PCN #189
Notification Date:
June 19, 2020

Product / Process Change Notice

Chip process CP371, N-channel MOSFETs, wafers and bare die.

Figure 1: CP371 Chip Geometry (Discontinued)

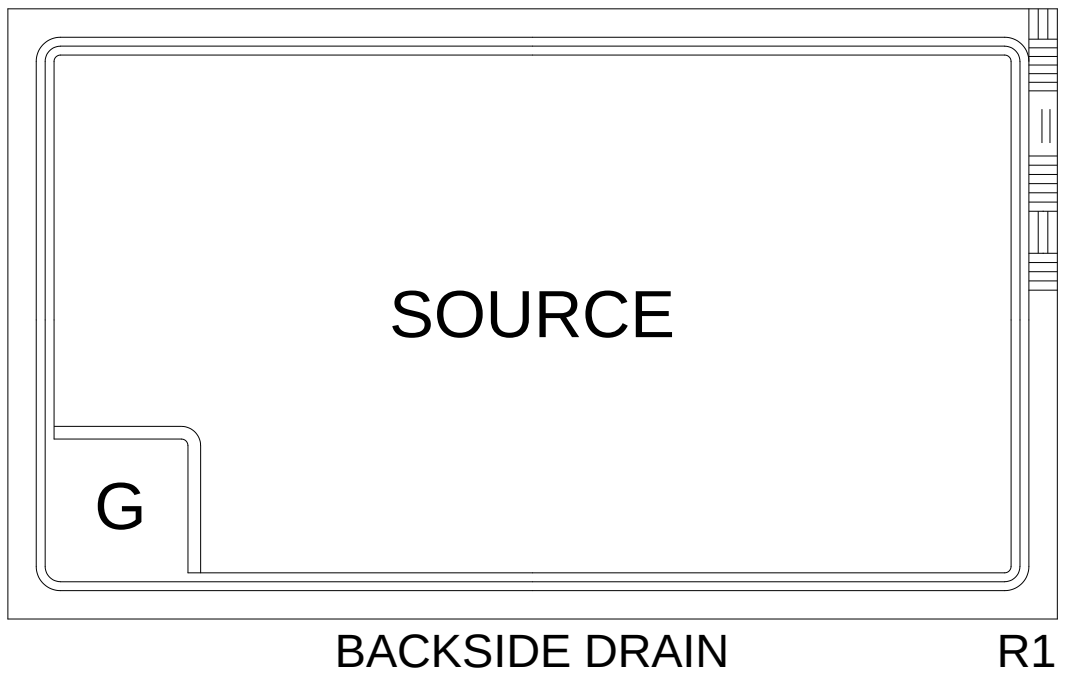
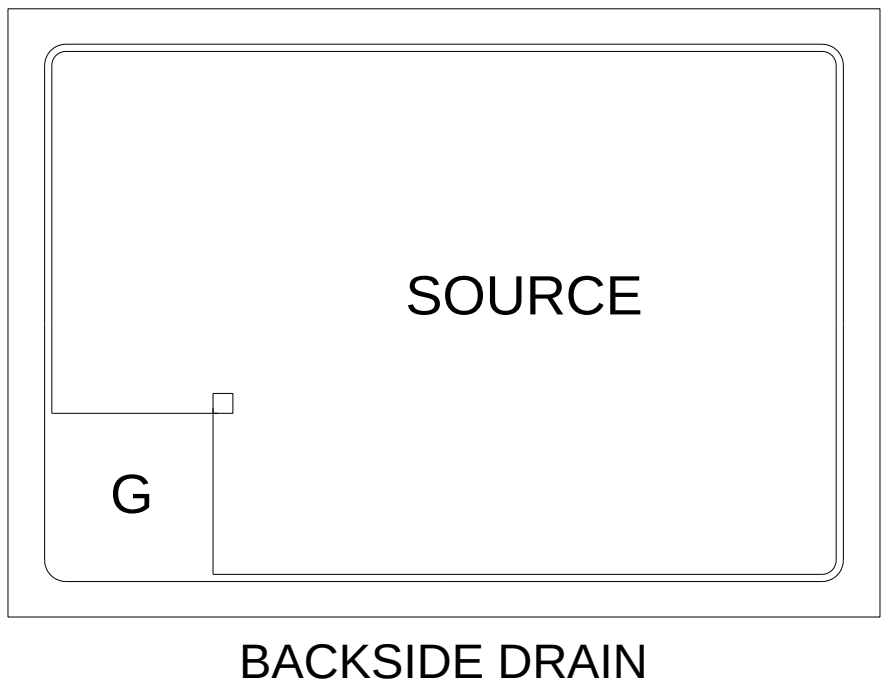
The CP371 wafer process has been discontinued and is being replaced with the CP405 wafer process. See Figures 1 and 2 for details.

Wafer Diameter:	8 inch
Die Size:	55 x 32 mils
Die Thickness:	7.5 mils
Bond Pad Size (Gate):	7.3 x 7.3 mils
Bond Pad Size (Source):	50 x 25 mils
Topside Metal:	Al (40,000Å)
Backside Metal:	Ti/Ni/Ag (1,000Å/3,000Å/10,000Å)

Figure 2: CP405 Chip Geometry

Wafer Diameter:	8 inch
Die Size:	45.7 X 31.9 mils
Die Thickness:	5.5 mils
Bond Pad Size (Gate):	8.1 x 8.1 mils
Bond Pad Size (Source):	41.9 x 28.2 mils
Topside Metal:	Al-Cu (40,000Å)
Backside Metal:	Ti/Ni/Ag (1,000Å/3,000Å/10,000Å)
